CURRENT DESIGN, AS DRIP TRAY IS SHIPPED

WHEN REPLACING THE LEGACY (PRE-2003) DESIGN HOOKS:  
REMOVE EXISTING HOOKS FROM DRIP TRAY ASSEMBLY  
AND REPLACE WITH 30-10644 AND 30-10645 AS SHOWN.

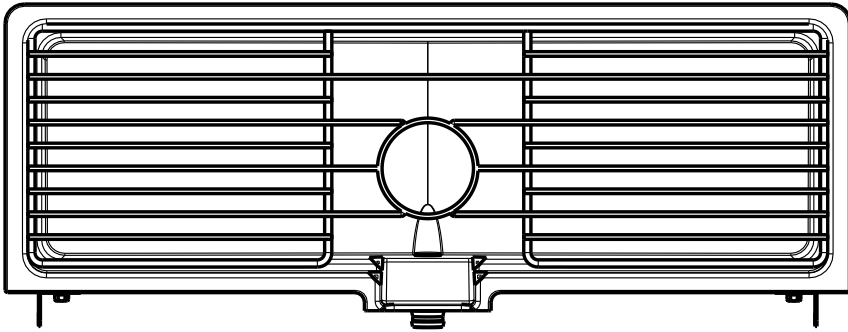
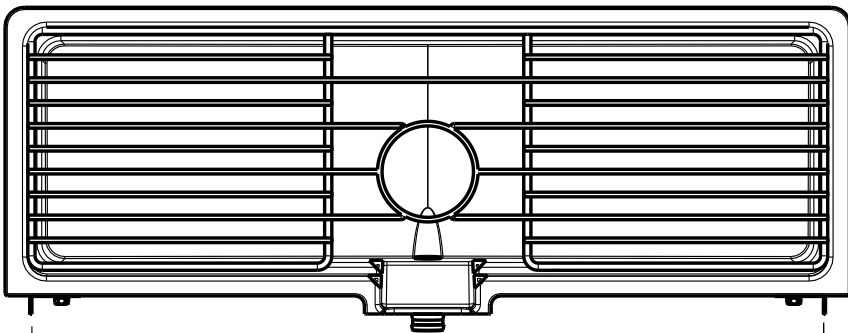
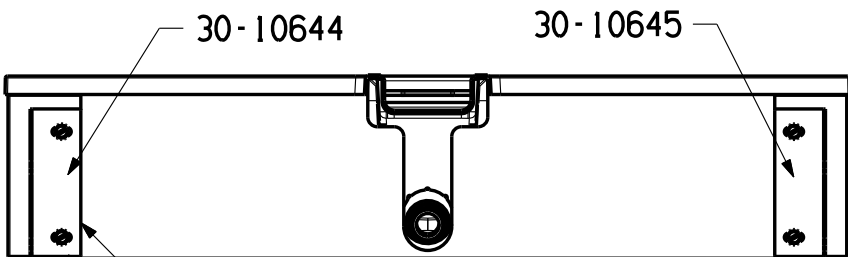
20.618  
SET THE DISTANCE BETWEEN  
HANGERS PER THIS DIMENSION  
.69

ALIGN EDGE OF HOOK  
WITH THESE EDGES
